ADDENDUM NO. 1

JOB NO. J32CO30A  
WAIMANALO WASTEWATER TREATMENT PLANT IMPROVEMENTS  
Waimanalo, Oahu, Hawaii

ISSUED: April 27, 2005

**△** ADDENDUM NO. 1  
 FIGURE NO. 1

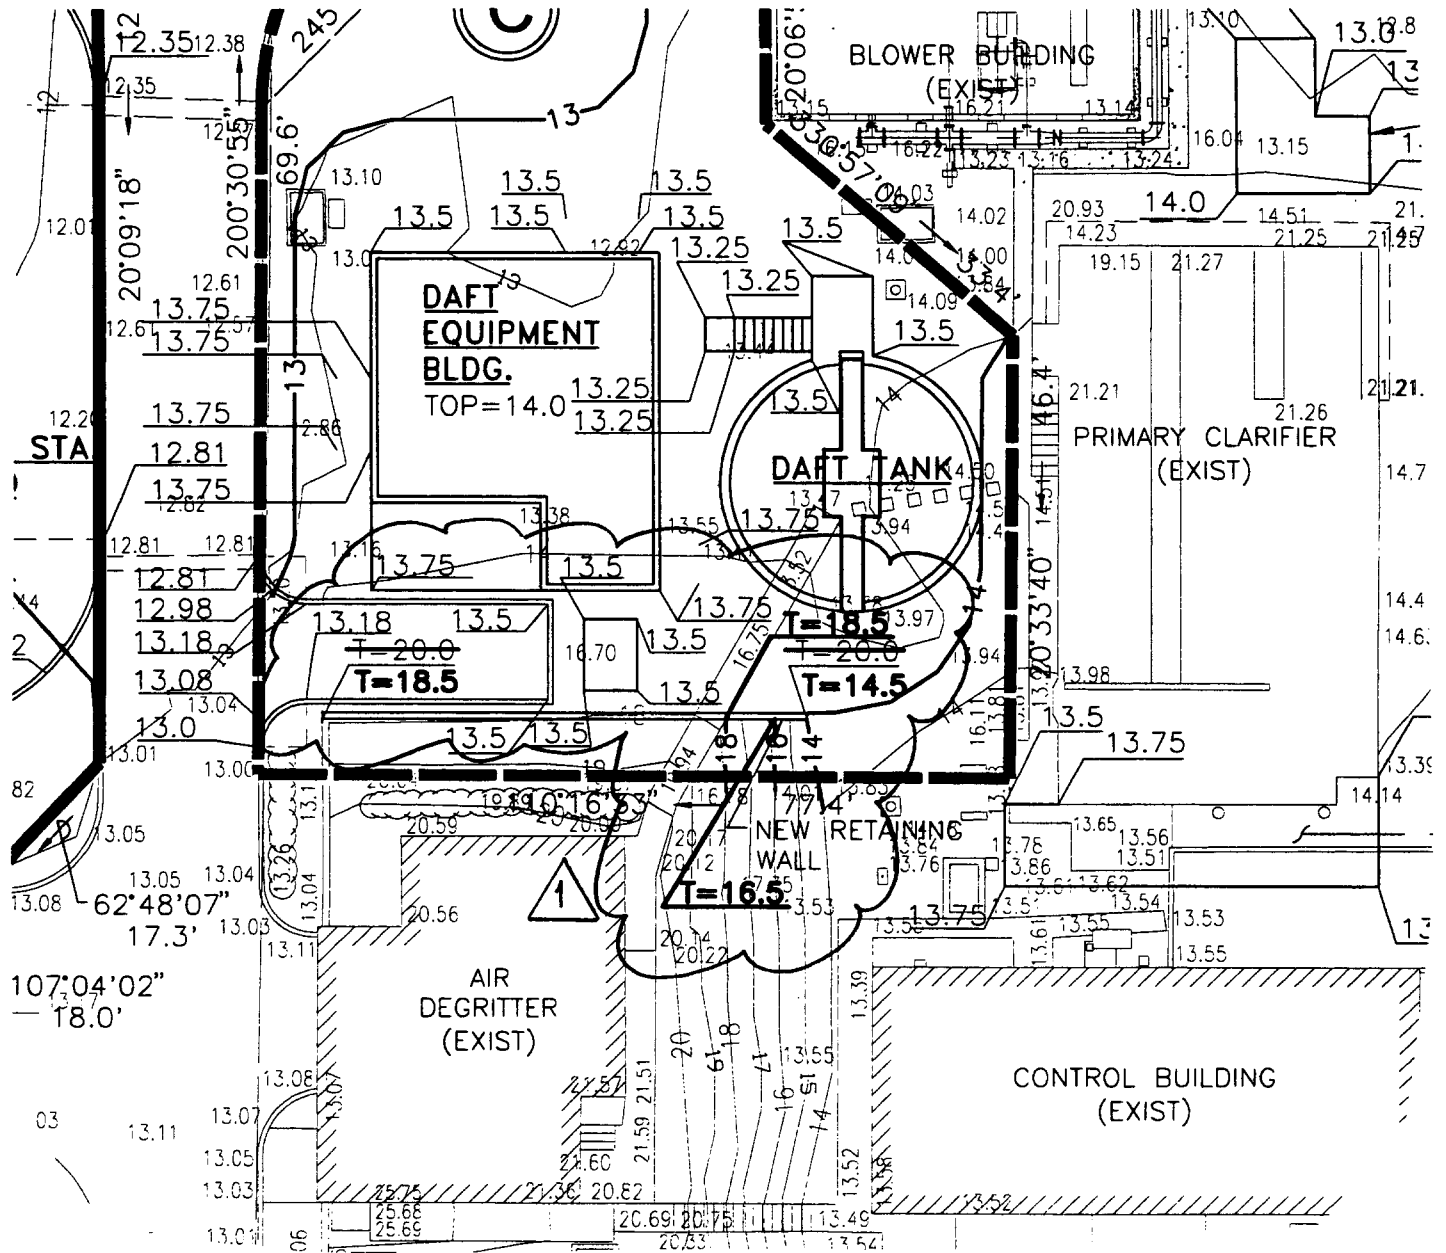
| <u>Figure</u> | <u>Drawing</u> | <u>Description</u>                    |
|---------------|----------------|---------------------------------------|
| 1             | C602           | Added callouts                        |

NARRATIVE OF REVISION: **ADDED CALLOUTS**

DWG. C608 SHT. 27 OF 291

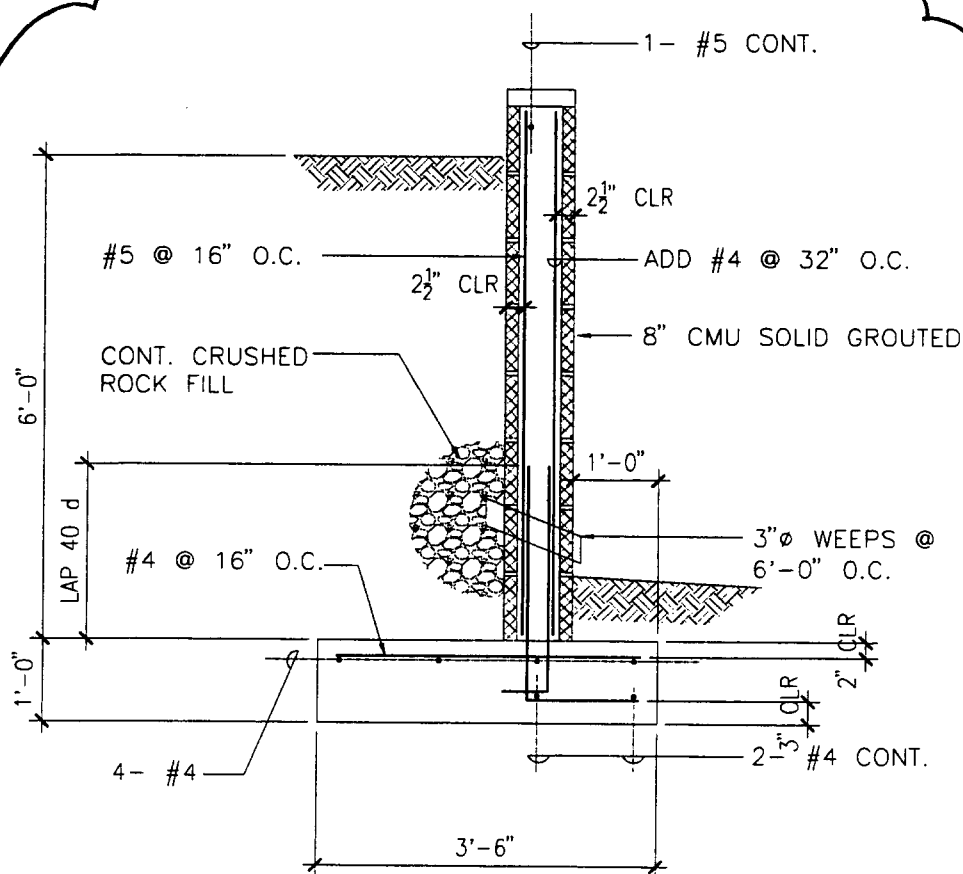
| <u>Figure</u> | <u>Drawing</u> | <u>Description</u>                    |
|---------------|----------------|---------------------------------------|
| 3             | C608           | Added landscaping notes               |

NARRATIVE OF REVISION: ADDED LANDSCAPING NOTES

1 ADDENDUM NO. 1  
FIGURE NO. 7

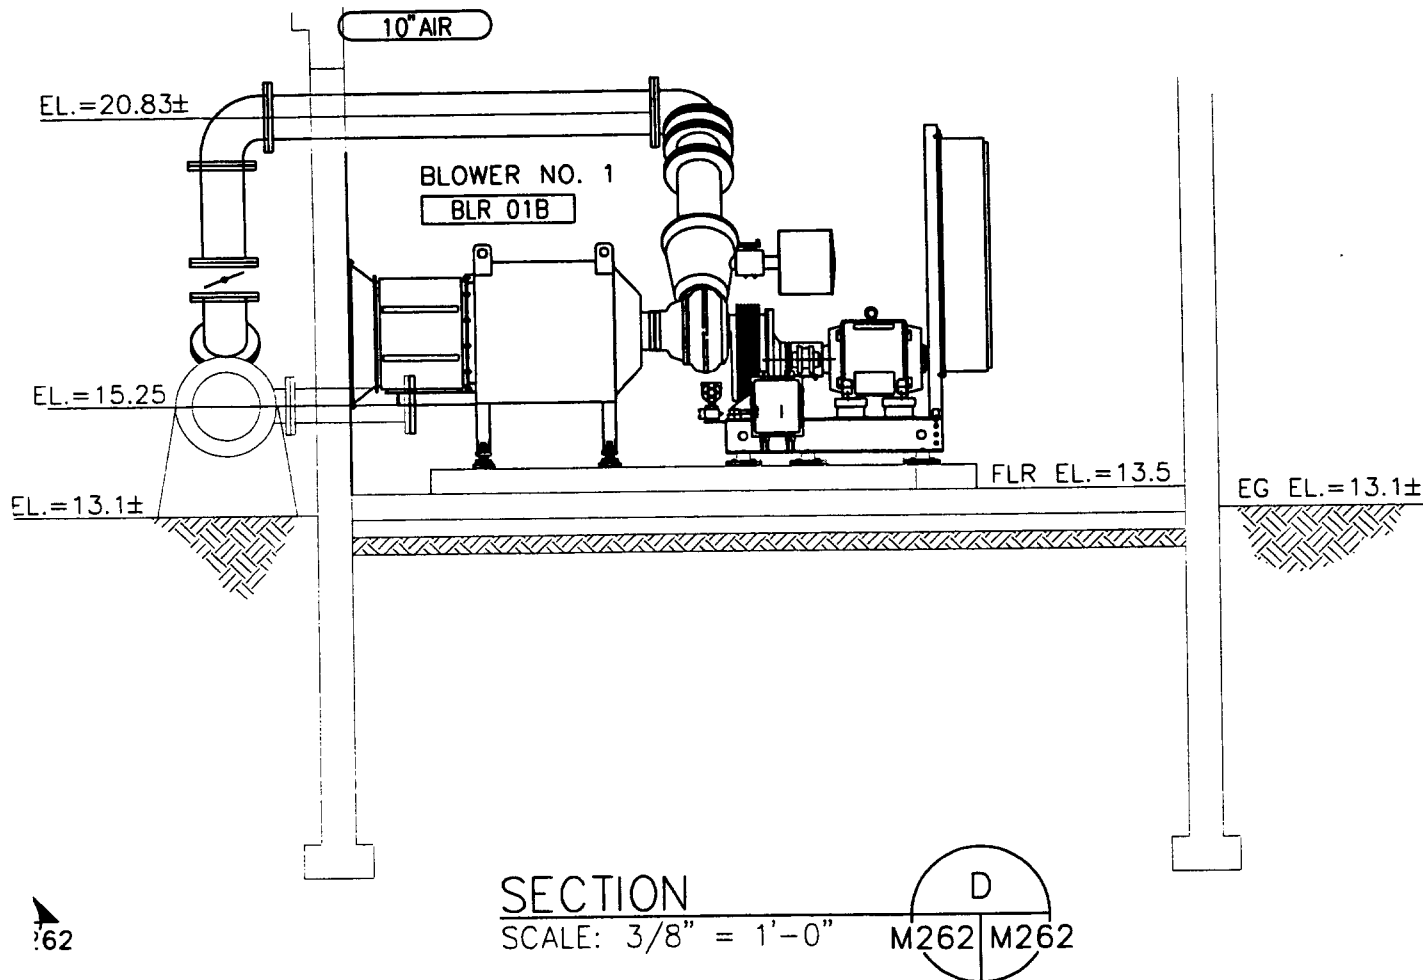
| <u>Figure</u> | <u>Drawing</u> | <u>Description</u>                    |
|---------------|----------------|---------------------------------------|
| 7             | N701           | Motor HP (150 -> 75)                  |

NARRATIVE OF REVISION: REVISED SINGLE-STAGE BLOWER MOTOR HP FROM 150HP TO 75 HP.
